STAFF RECOMMENDATION
1013 Petway Avenue
November 19, 2014

Application: New construction - Infill
District: Greenwood Neighborhood Conservation Zoning Overlay
Council District: 06
Map and Parcel Number: 08301023200
Applicant: David Baird, Architect
Project Lead: Sean Alexander, sean.alexander@nashville.gov

Description of Project: The applicant proposes to build a one and one-half story house on the lot. The scale and form of the house will be similar to that of a Craftsman style house, a common historic house in the area.

① SITE PLAN
 1" = 20'-0"
 0 5' 10' 20'

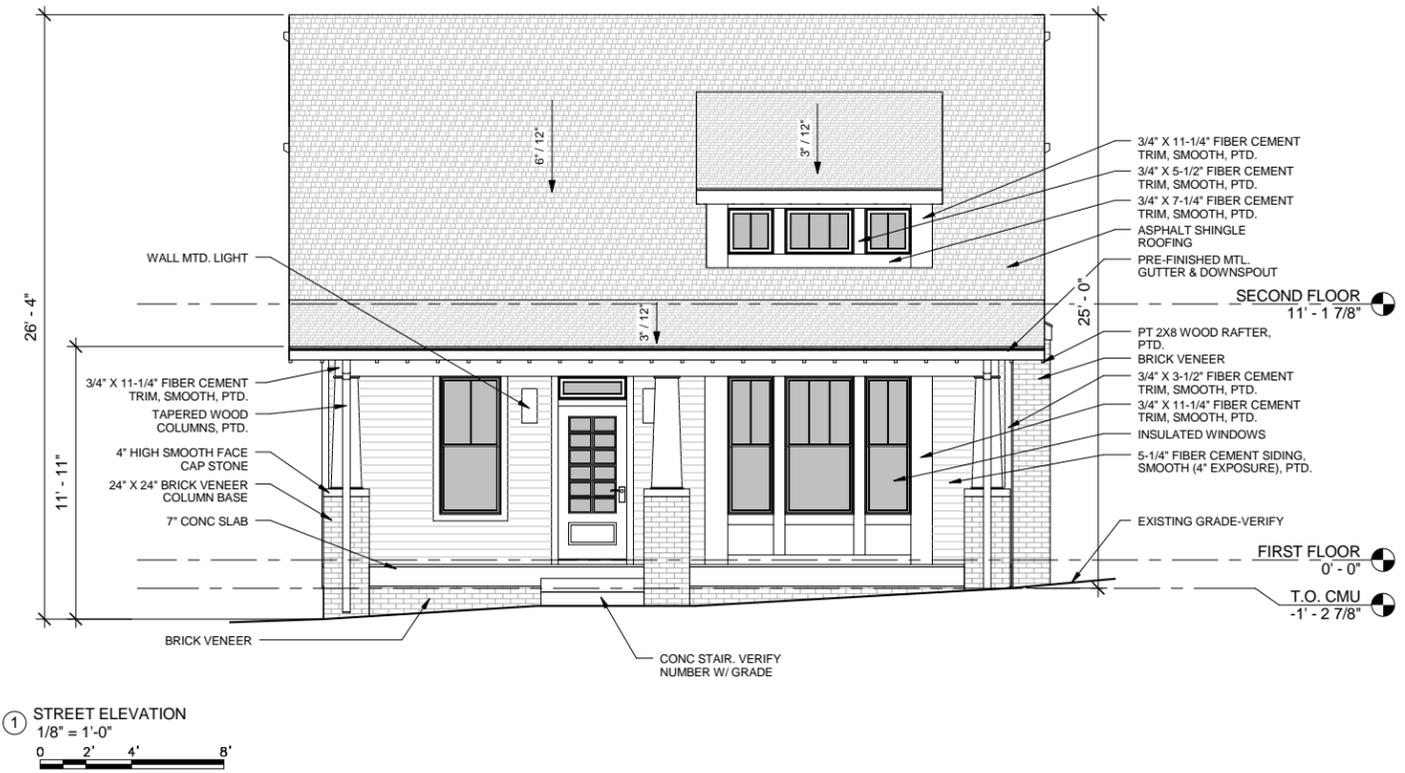
Setback & Rhythm of Spacing: The new house sit roughly thirty-three feet (33') back from the front edge of the property, in line with adjacent historic houses. The house will sit five feet (5') from the right boundary of the property and fifteen feet (15') from the left, with a driveway running along the left side of the house. Although there is an alley at the rear of the property, driveways are typical for the street because the lots are very deep and have a steep drop in grade toward the rear. Staff finds that these setbacks are consistent with those of surrounding historic houses. The project meets section II.B.1.c.

Appurtenances & Utilities: The existing gravel driveway on the left side of the lot will be extended to the midpoint of the new building. The existing gravel driveway will be extended to reach the midpoint of the structure on the left side. The HVAC condensers will also be located on the left side of the house, behind the midpoint. The project meets section II.B.1. i.

① STREET ELEVATION
1/8" = 1'-0"
0 2' 4' 8'

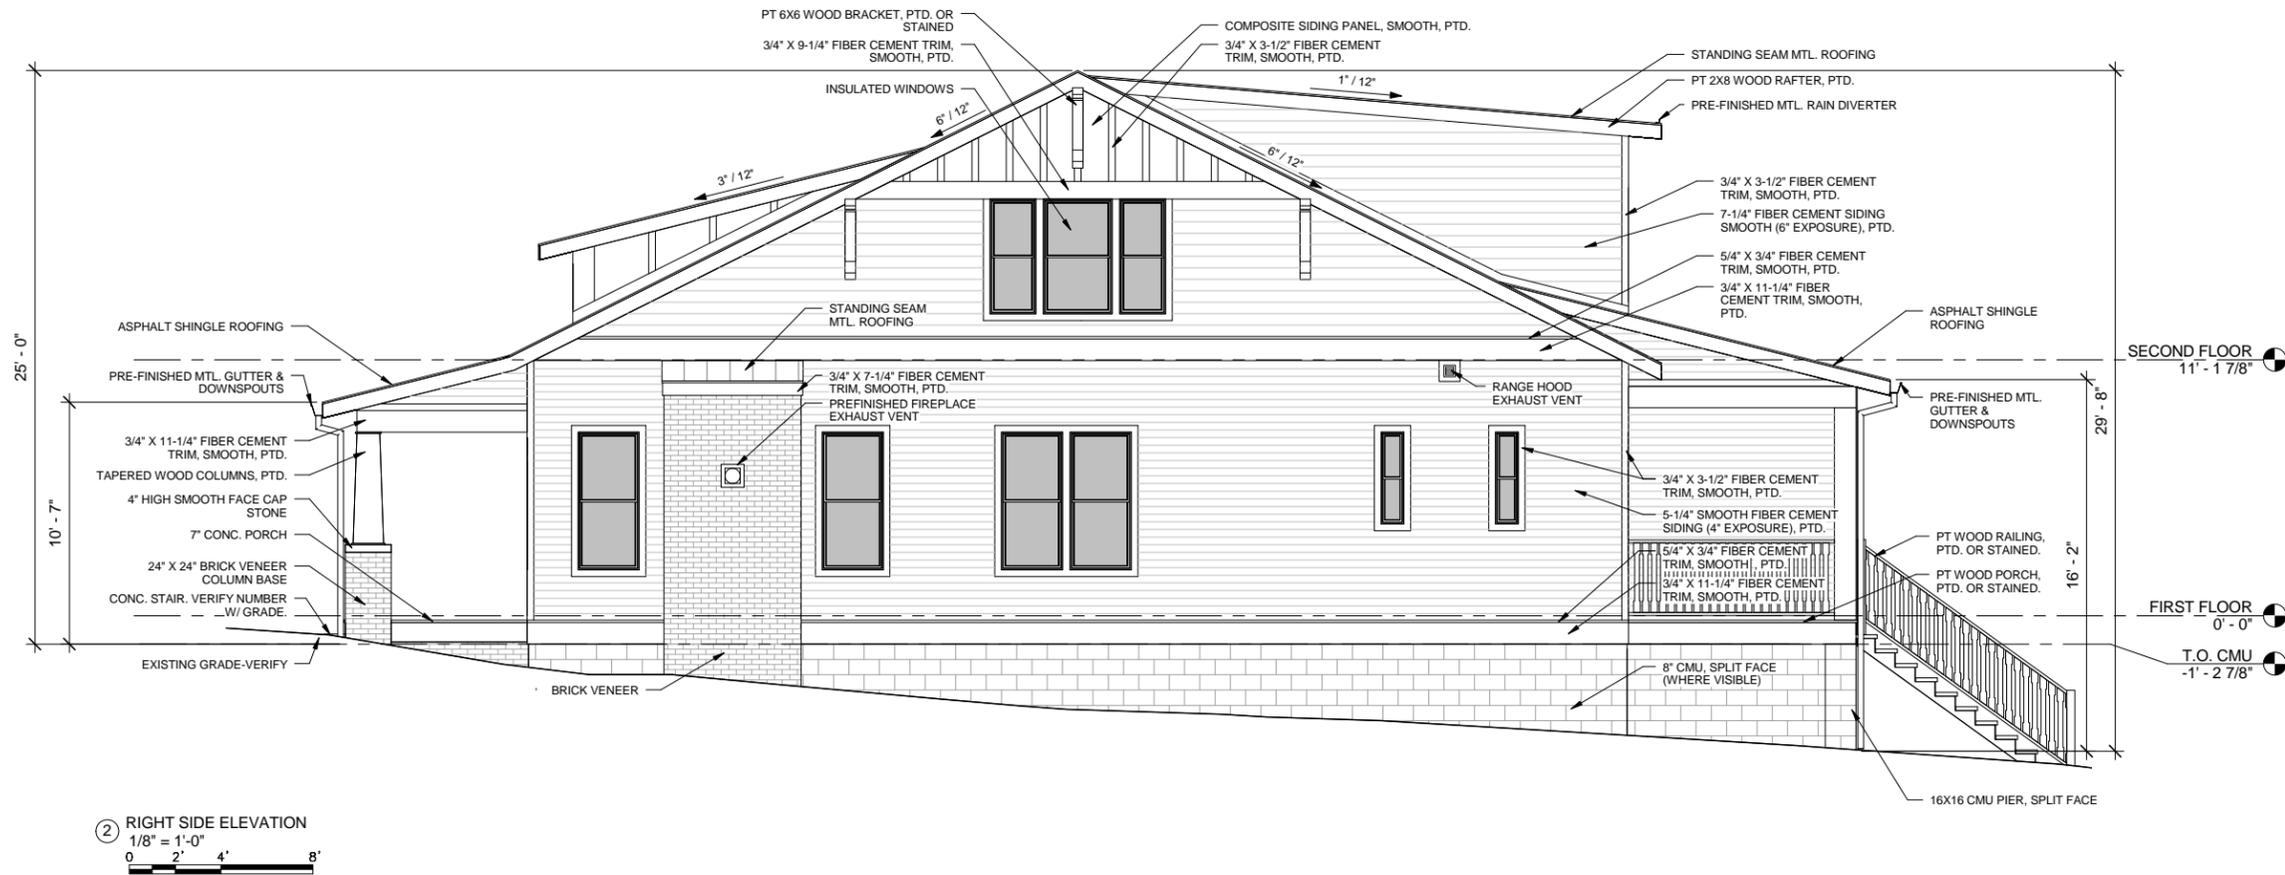
Height & Scale: The new house will be one and one-half stories tall. This is compatible with the surrounding historic context, consisting of one and one-half story Craftsman and Transitional Victorian houses. The peak of the roof of the house will be twenty-four feet (24') above the finished floor level. With a two-foot (2') tall exposed foundation, the overall height of the building will be twenty-six feet (26'). The leading eave height of the house will be eight feet (8') above the finished floor level. By comparison, surrounding houses are between twenty feet (20) and thirty-one feet (31') tall. The historic house to the immediate left is thirty-one feet (31') tall.

Materials: The new house will primarily be clad in smooth face cement fiberboard with a reveal of four inches (4”) on the first story and six inches (6”) on the second. The trim will also be cement-fiberboard. A chimney on the right side and the bases of the front porch columns will be brick. The color and texture of the brick is not known. The foundation will be split-faced concrete block, and the roof will be architectural fiberglass shingle. The color of the roof is not known. The material of the windows and doors also is not known.

Roof form: The roof will be a side-oriented gable with a pitch of 6:12. A shed-roofed front dormer and the full-width front porch will have a pitch of 3:12. These roofs are compatible with those of historic houses in the area. The project meets section II.B.1.e.

Proportion and Rhythm of Openings: The windows on the proposed infill are generally twice as tall as they are wide, thereby meeting the historic proportions of openings. There are no large expanses of wall space without a window or door opening. Staff finds the project’s proportion and rhythm of openings to meet Section II.B.1.g.

Staff recommends approval of the proposed infill at 1013 Petway Avenue with a condition that Staff reviews and approves the final selection of windows and doors, roof color, brick color and texture. Meeting this condition, Staff finds the application to meet the applicable design guidelines for the Greenwood Neighborhood Conservation Zoning Overlay.
